Up Grade

Motor Driver Board 1.864.125.20

Description

Software version V3.00 and higher need certain hardware upgrade and controls those transports with boost effect (accelerates tape locate). See also SN 2000-03.

Figure 1 - Wiring details of Motor Driver Board 1.864.125.20 to Motor Driver Board 1.864.125.21

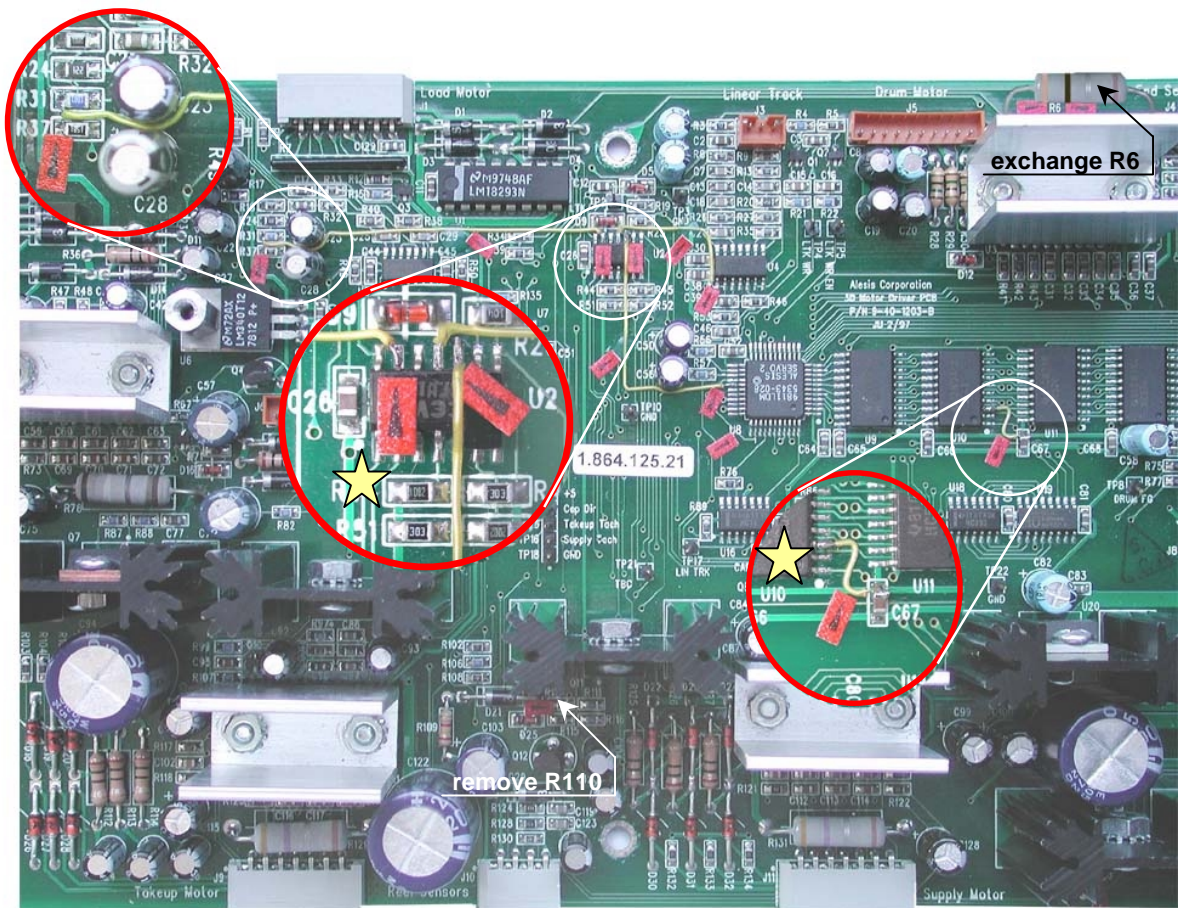
lift pins before wiring! - see Instructions for Capstan Boost Modification

1. Lift U2 (LM339) pins 10, 11 and 13, U10 (74HC541) pin 3 on Motor Driver Board
2. Connect jumper (*) from U10 pin 3 to U11 pin 20
3. Connect jumper (*) from U8 pin 27 to U2 pin 10
4. Connect jumper (*) from U2 pin 11 to U4 pin 1
5. Connect jumper (*) from U2 pin 13 to R31/R37
6. Exchange R6 (0.68Ω) with 1.0Ω/3W/2% (Distrelec order no. 713177)
7. Remove resistor R110
8. Stick label „1.864.125.21“ onto label „1.864.125.20“
(* use wire wrap 1.010.110.64 or certain wire Ø 0.2mm)

Schematic of Motor Driver Board 1.864.125.21 (part 2)

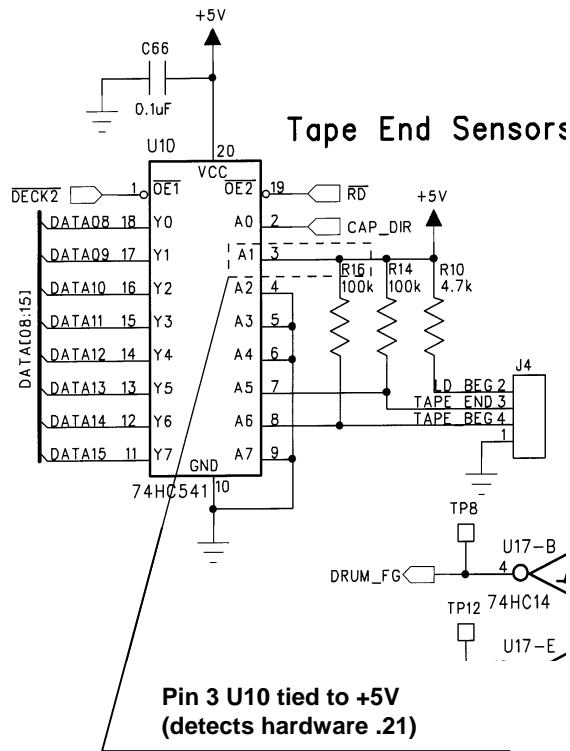
**Resistor R110 Ohm (SMD)
must be removed (let open)**

**Pin 3 U10 tied to +5V
(detects hardware .21)**

Figur 1 - Umbau-Details vom Motor Driver Board 1.864.125.20 auf Driver Board 1.864.125.21

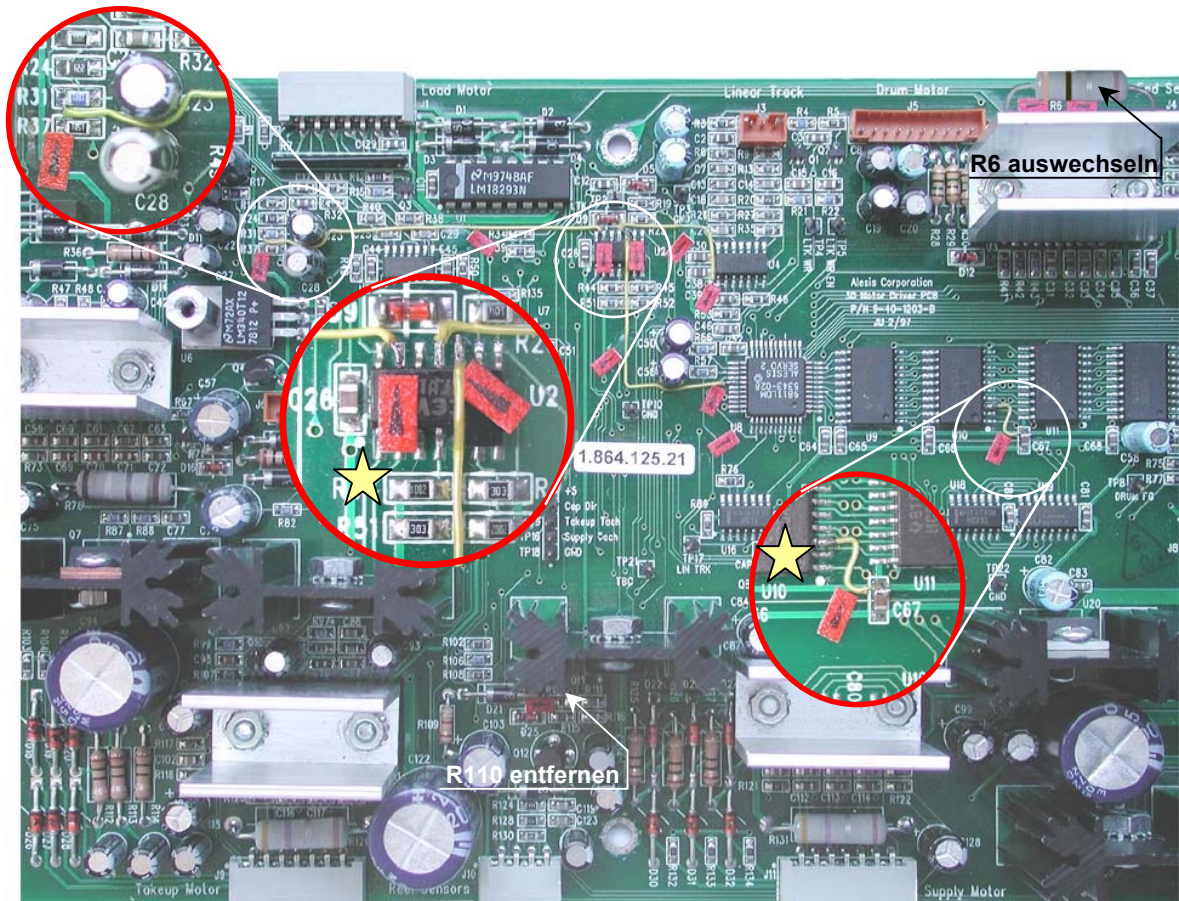
Pins vor dem Löten vom Pad entfernen (nach oben biegen)! - Siehe Anleitung

1. Nach oben biegen: Pin 10, 11 and 13 von U2 (LM339), Pin 3 von U10 (74HC541); Pins zeigen in die „Luft“
2. Wire Wrap * Verbindung: Pin 3 von U10 mit Pin 20 von U11
3. Wire Wrap * Verbindung: Pin 27 von U8 mit Pin 10 von U2
4. Wire Wrap * Verbindung: Pin 11 von U2 mit Pin 1 von U4
5. Wire Wrap * Verbindung: Pin 13 von U2 zu R31/R37
6. Ersetzen von R6 (0.68Ω) gegen 1.0Ω/3W/2% (Distrelec order no. 713177)
7. Entfernen von Widerstand R110
8. Label „1.864.125.21“ auf altes Label „1.864.125.20“ kleben
(* Wire Wrap Draht Ø 0.2mm 1.010.110.64 oder ähnlich)

Schema des Motor Driver Board 1.864.125.21 (Teil1)

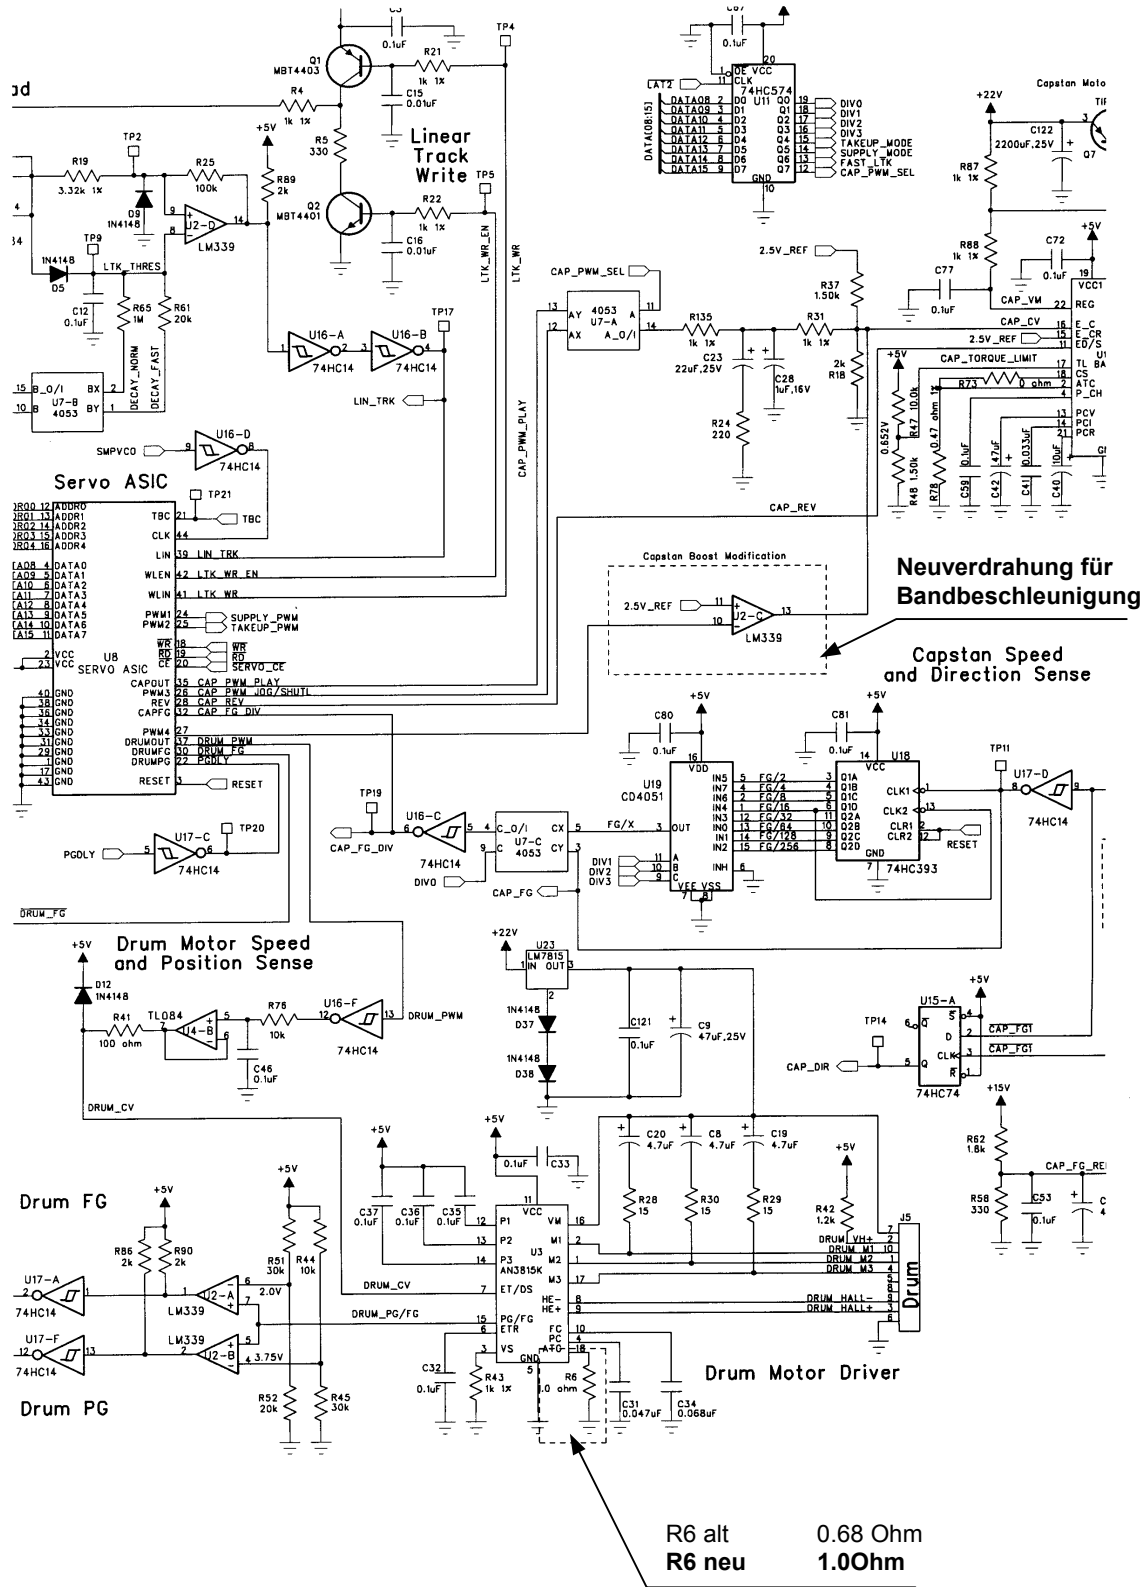
Widerstand R110 Ohm (SMD) muss ersatzlos ausgelötet werden.
